#### **ADDENDUM #1**

Date: June 16, 2021

# DPW PROJECT NO. 20-603 IDVS: REMODEL STAFF LOUNGE, VET-P IDAHO STATE VETERANS HOME POCATELLO, IDAHO

ADD1.0

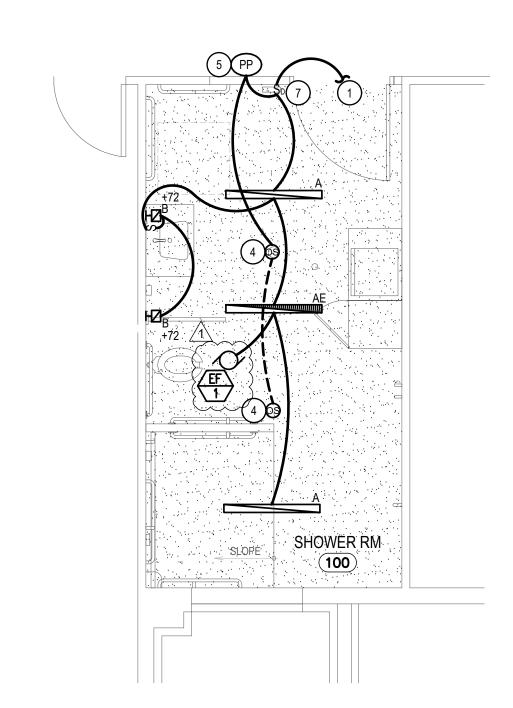
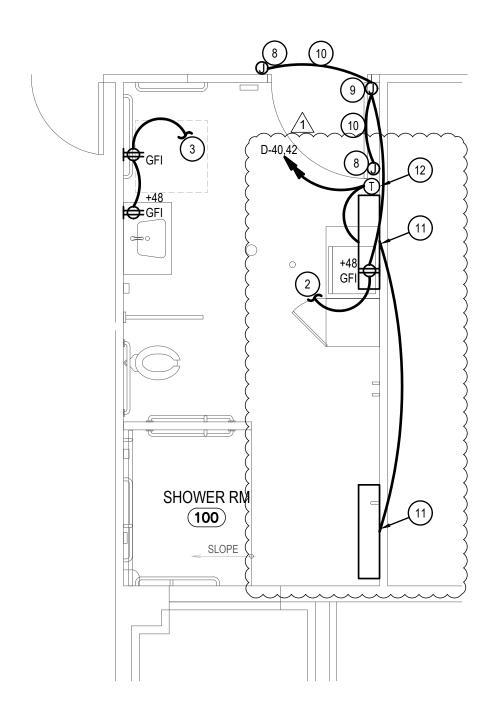
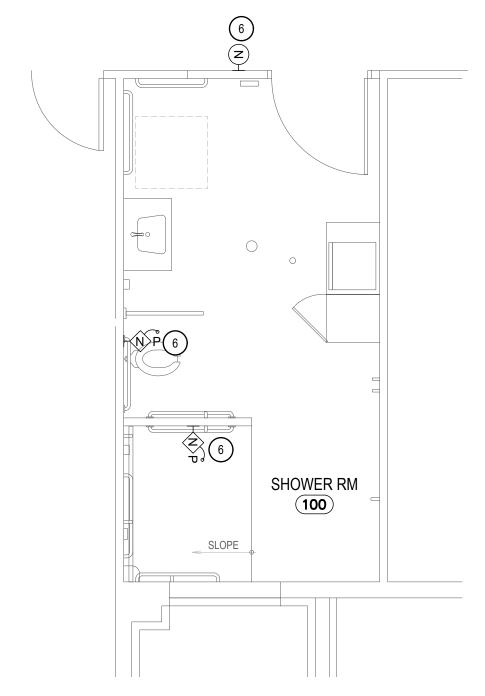
1. Mount wall sconces on either side of vanity as shown in elevation A on sheet ADD1.0. Vanity/wall sconce Elevation A on sheet ADD1.0 to replace Vanity/wall sconce Elevation E on sheet A3.1.

1 ADDENDUM #1

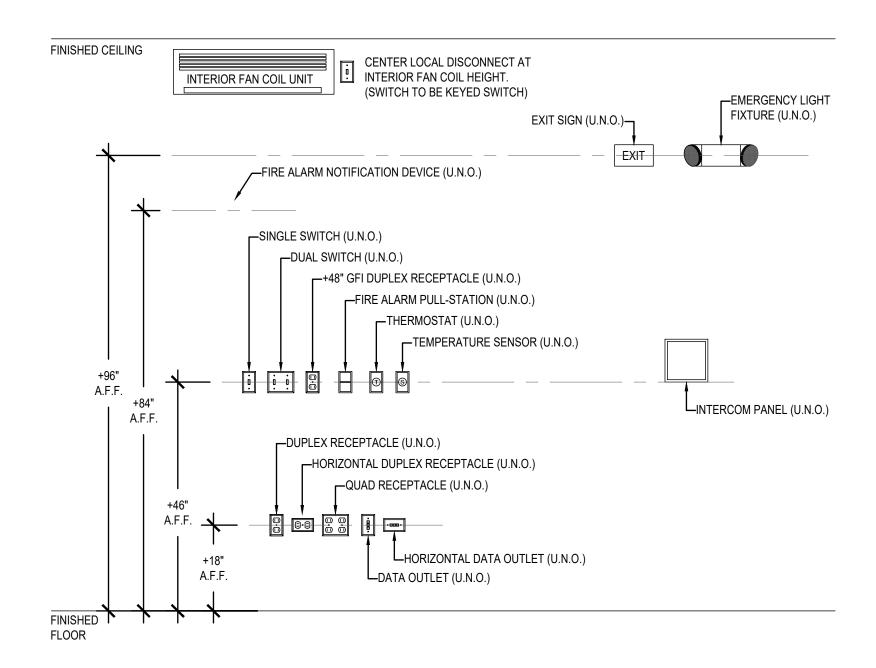
1. Delete (1) wall mounted cove heater QMARK Model RCC 12008C 94" long or equal denoted as CH 1 and shown in Floor Plan – Mechanical on sheet MP1.1. Add (2) cove heaters QMARK Model RCC 6008C 47" long or equal. Install heaters and thermostat in location shown on sheet E2.0.

- INSTALL COVE HEATER. VERIFY INSTALLATION WITH OPERATOR
- 12. INSTALL LINE VOLTAGE THERMOSTAT. VERIFY INSTALLATION WITH

- INSTALLATION MANUAL. COVE HEATER: QMARK RCC6008C OR EQUAL

THERMOSTAT: QMARK MS26C OR EQUAL
